## Product Change Notice (PCN)

PCN Number: **PCN-0451206R-01**

Product(s) Affected: **PJ-058A**

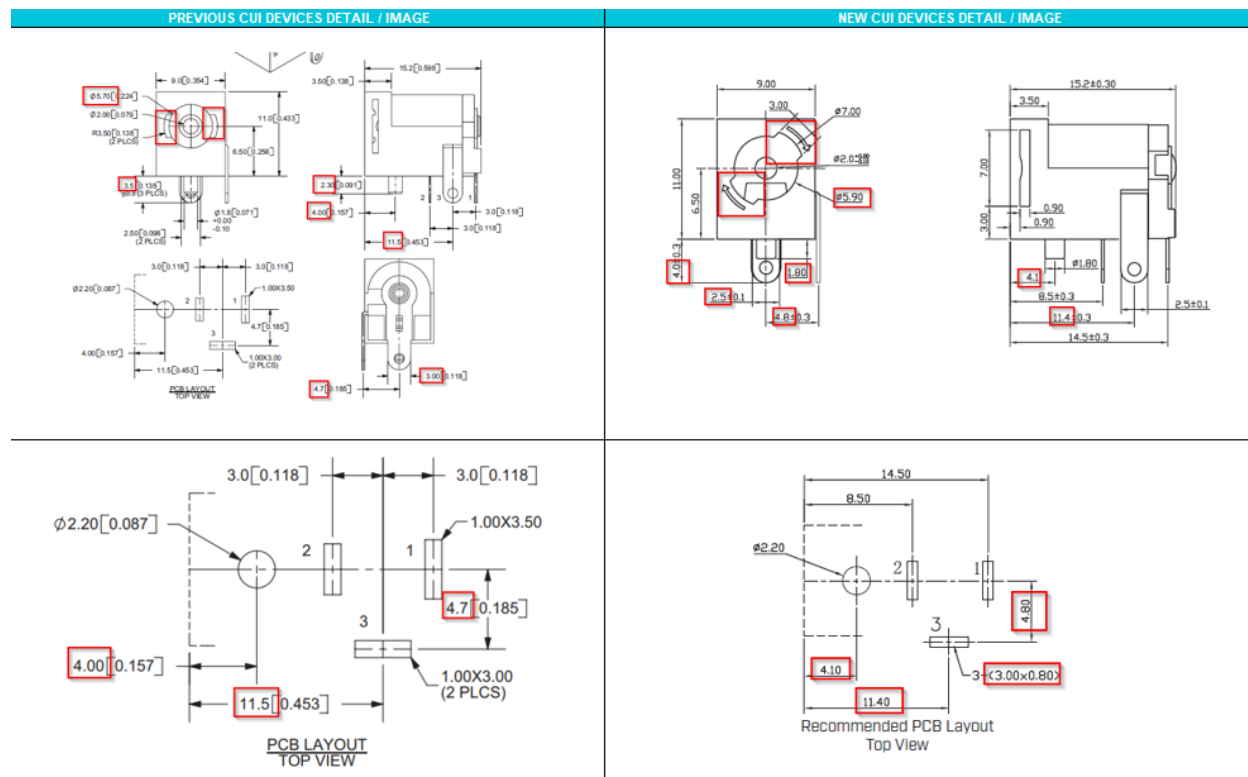
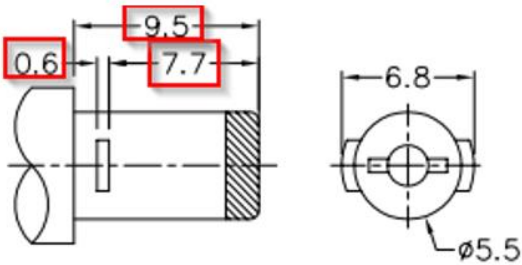
Description of Change: **Minor Housing and footprint differences. Material Change on the housing and terminals. See image Below**

| PREVIOUS CUI DEVICES DETAIL / IMAGE |              |         | NEW CUI DEVICES DETAIL / IMAGE |               |               |
|-------------------------------------|--------------|---------|--------------------------------|---------------|---------------|
| center pin                          | copper       | nickel  | center pin                     | brass         | nickel        |
| terminal 1                          | brass        | silver  | terminal 1                     | brass t=0.30  | silver        |
| terminal 2                          | copper alloy | silver  | terminal 2                     | bronze t=0.25 | silver        |
| terminal 3                          | brass        | silver  | terminal 3                     | brass t=0.30  | silver        |
| plastic                             | PBT          |         | cover                          | PBT (UL94V-0) | black         |
|                                     |              |         | housing                        | PBT (UL94V-0) | black         |

**MATING PLUG**  
Jack Insertion Depth: 9.8 mm

**MATING PLUG**  
Jack Insertion Depth: 9.5 mm
